Product Change Notification

Change Notification #: 117008 - 00

Change Title: Intel® Server System R1304WFTYSR, PCN 117008-00, Product Design, Label, Update BIOS/BMC/ME/FRUSDR Firmware System outer box J33994-001 stacking logo update. 1100W Power Supply Add URL to BIS mark

Date of Publication: June 17, 2019

Image 1. Power supply label before change

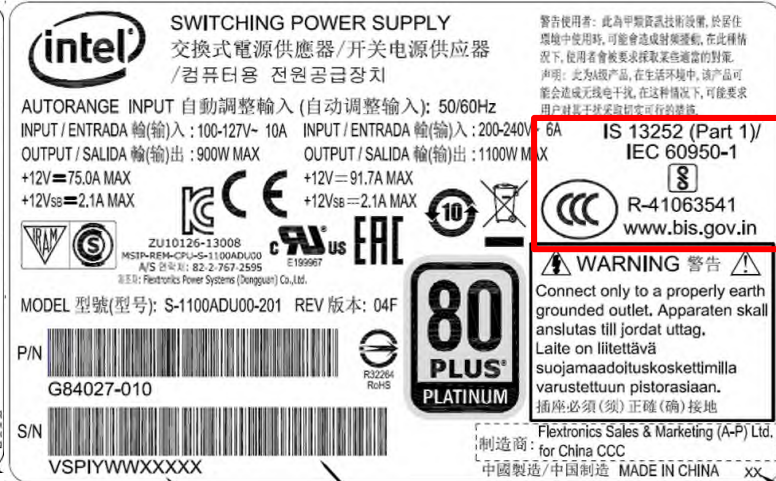
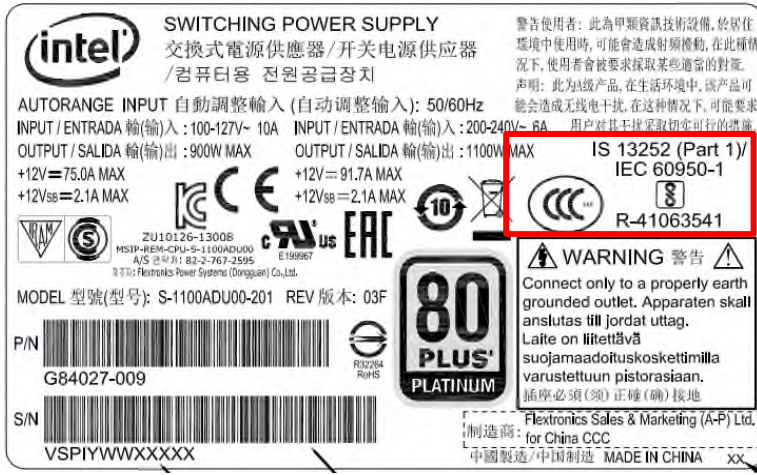
Intel is updating the label of the 1100 power supply. The new label includes a URL of the BIS mark and remove "S&E" inside the CCC logo.

Image 2. Power supply label after change
